Gold Bar Waste Water Treatment Plant (GBWWTP) South Access Stairway

Site Location Study Pursuant to Bylaw 7188
Final Report

Project Number EP-977
May 2022

Subject: AA21-70 Gold Bar WasteWater Treatment Plant (GBWWTP) South Access Stairway EIA and SLS- Sign off

**PEDESTRIAN ACCESS UPGRADE
SOUTH GATE**

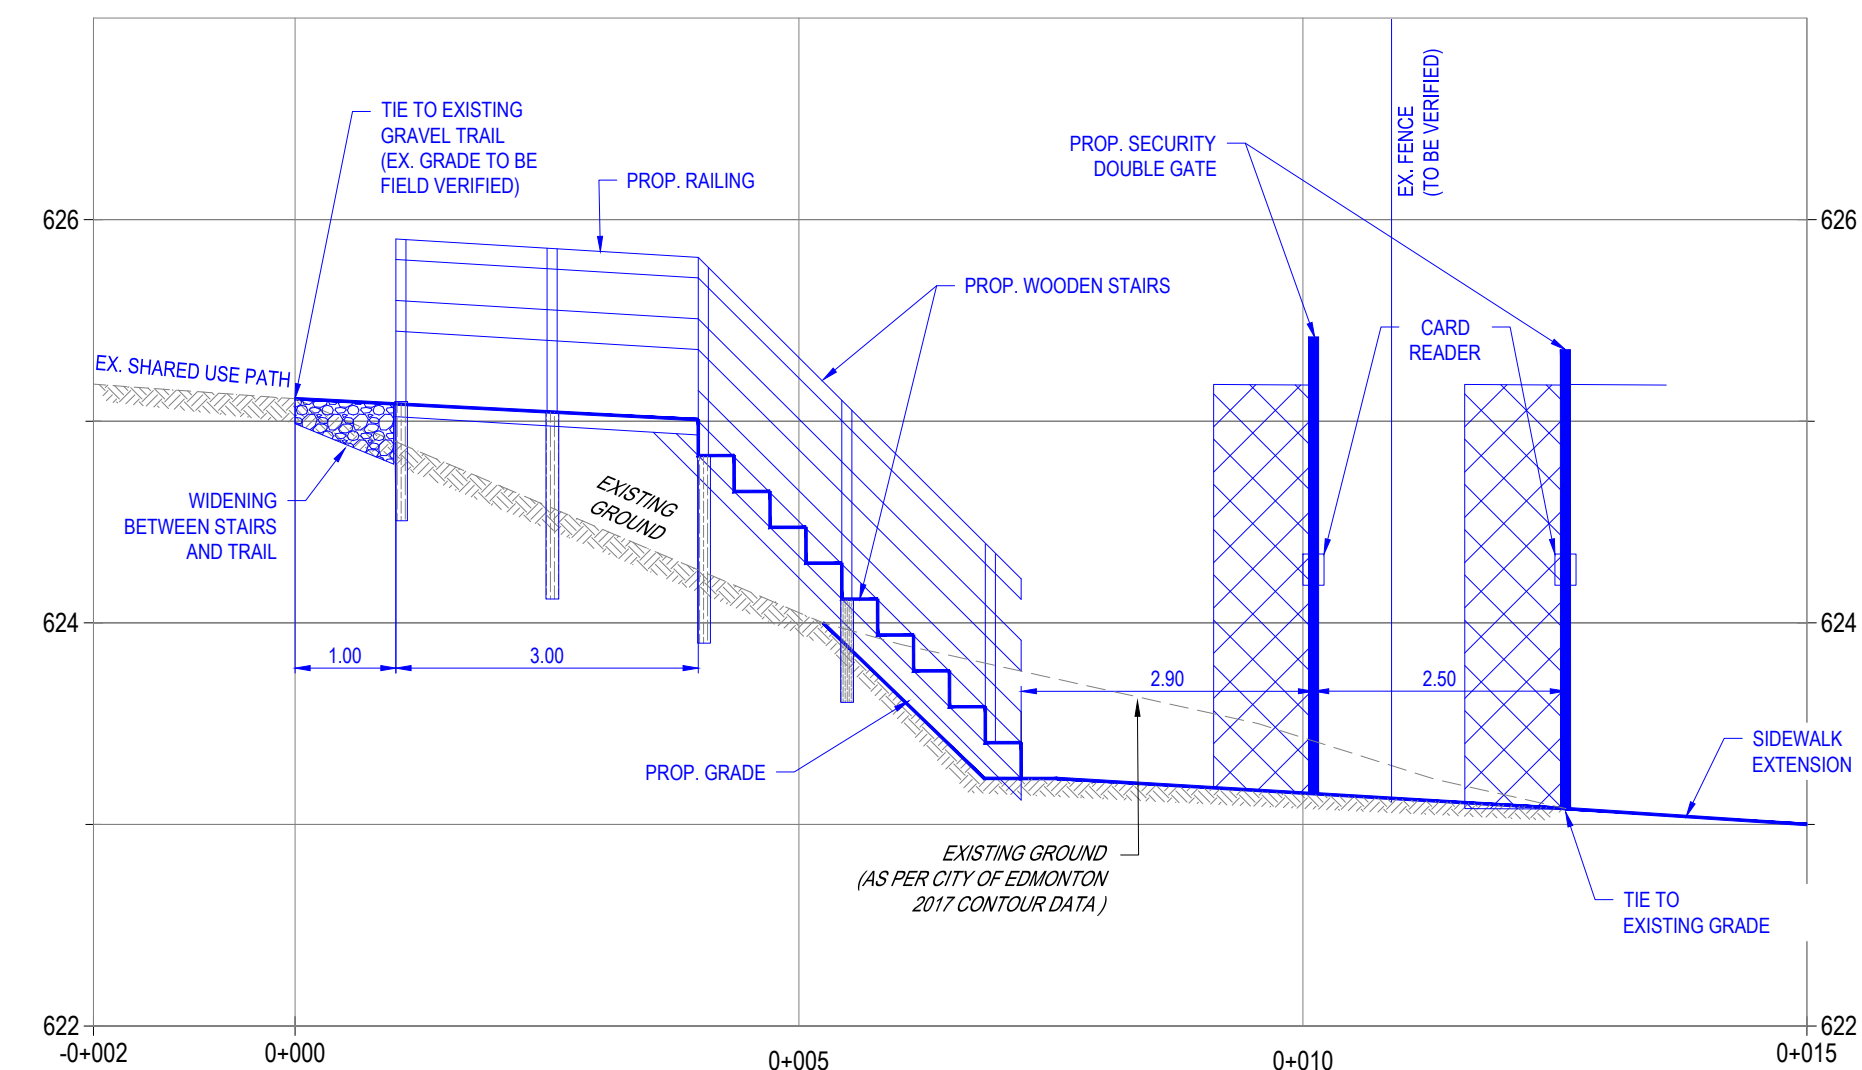
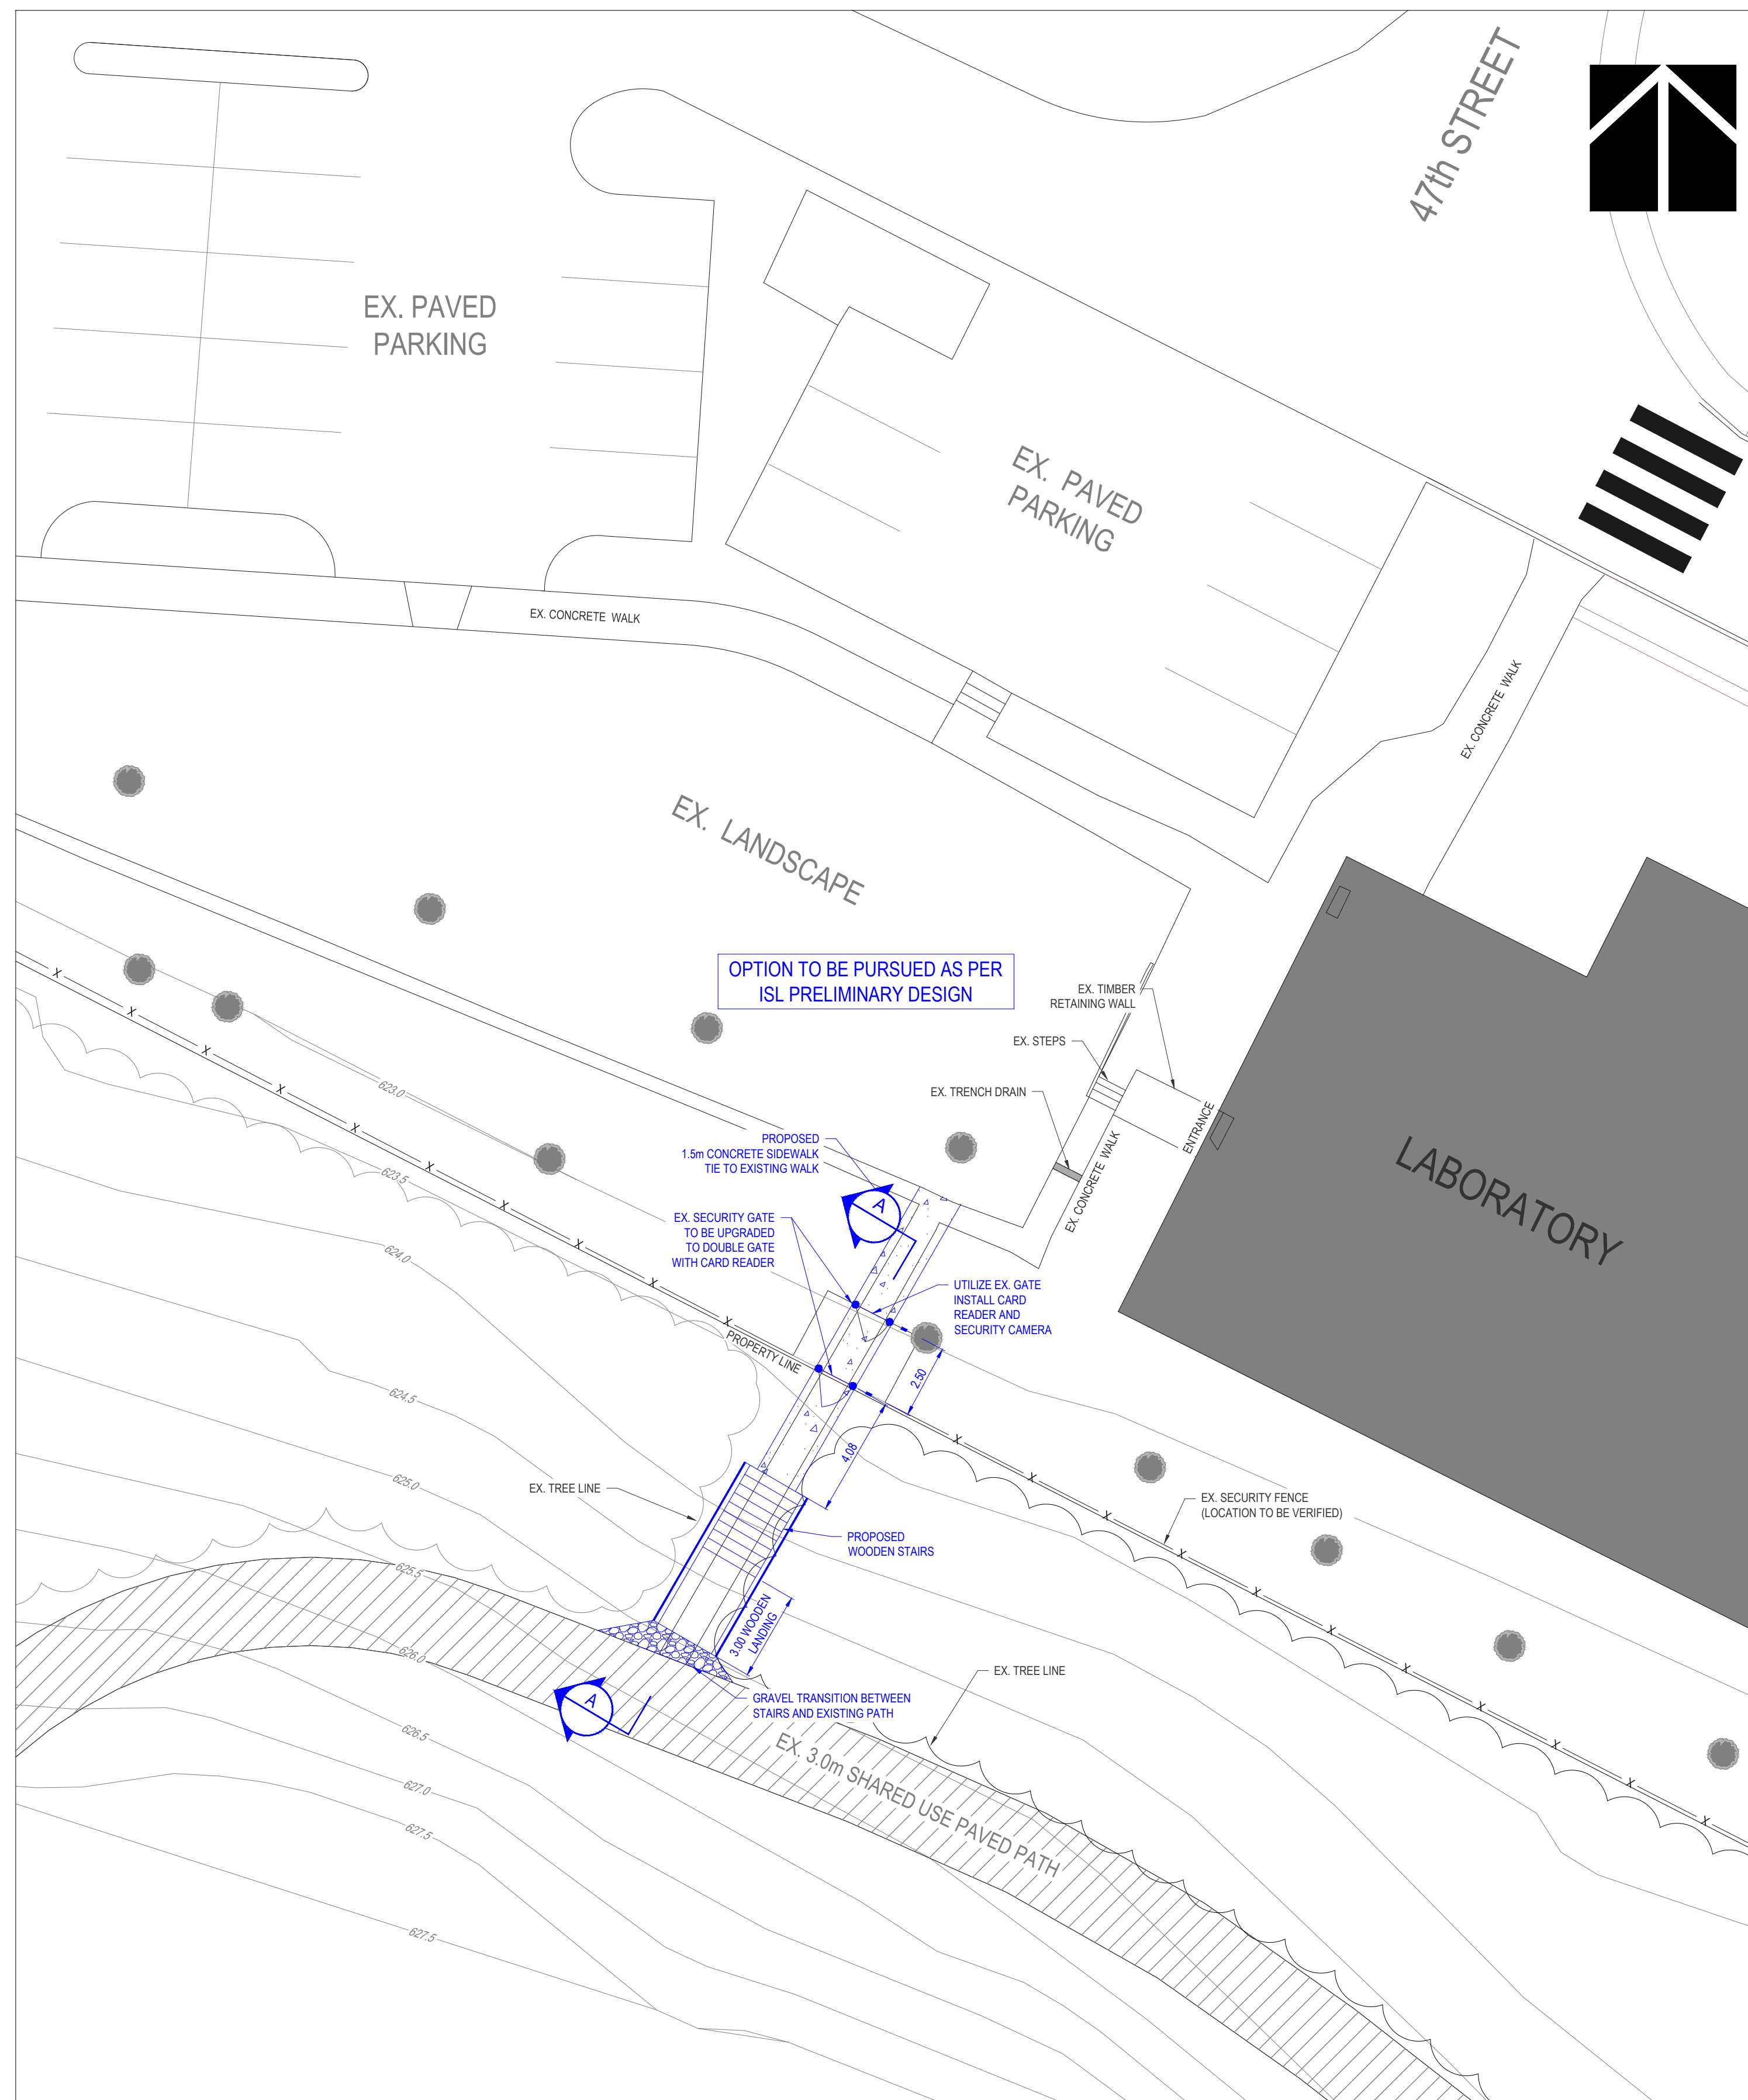
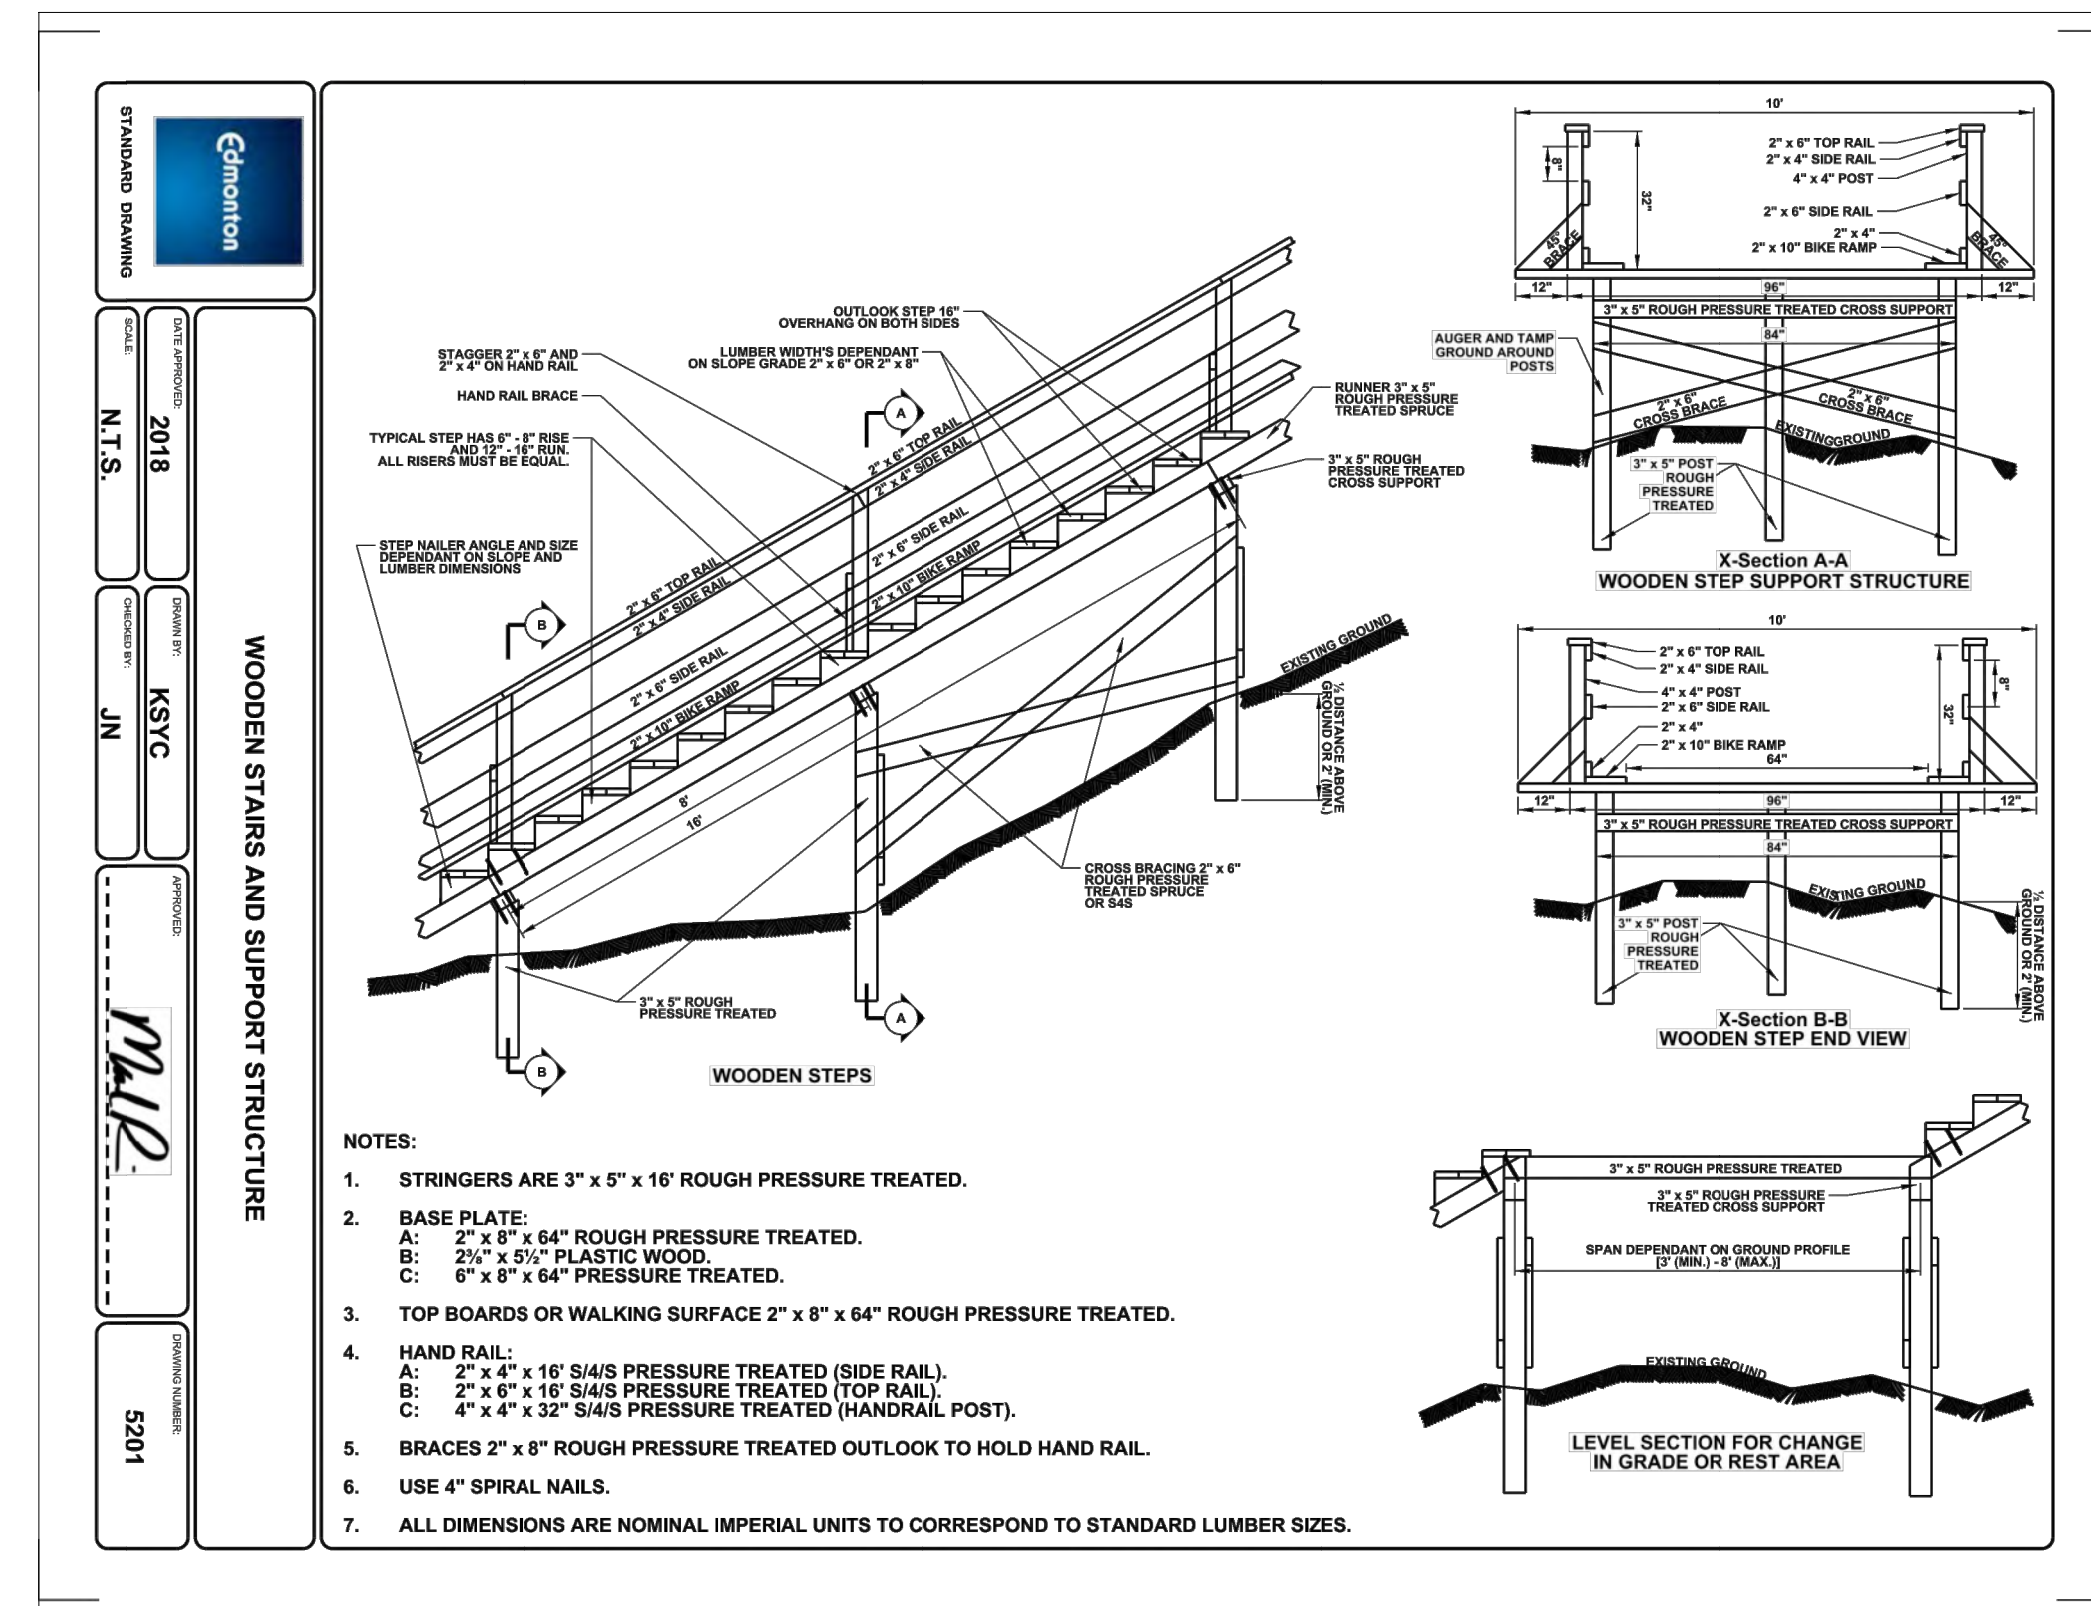
The stairway is proposed to be built on top of a shallow sanitary main, just north of the shared-use trail. Detailed plans for the location of the piles will need to be reviewed and approved prior to construction. Plans are to be submitted to wass.drainage@epcor.com for review.

Note: There is a shallow 200mm sanitary main beneath the proposed stairway just north of the shared use trail.

An approved Tree Preservation Plan will be required prior to construction which must be included in the application for a Tree Permit, as per the Public Tree Bylaw 18825. Please note that any grading for the staircase will impact the adjacent vegetation and this should be taken into consideration.
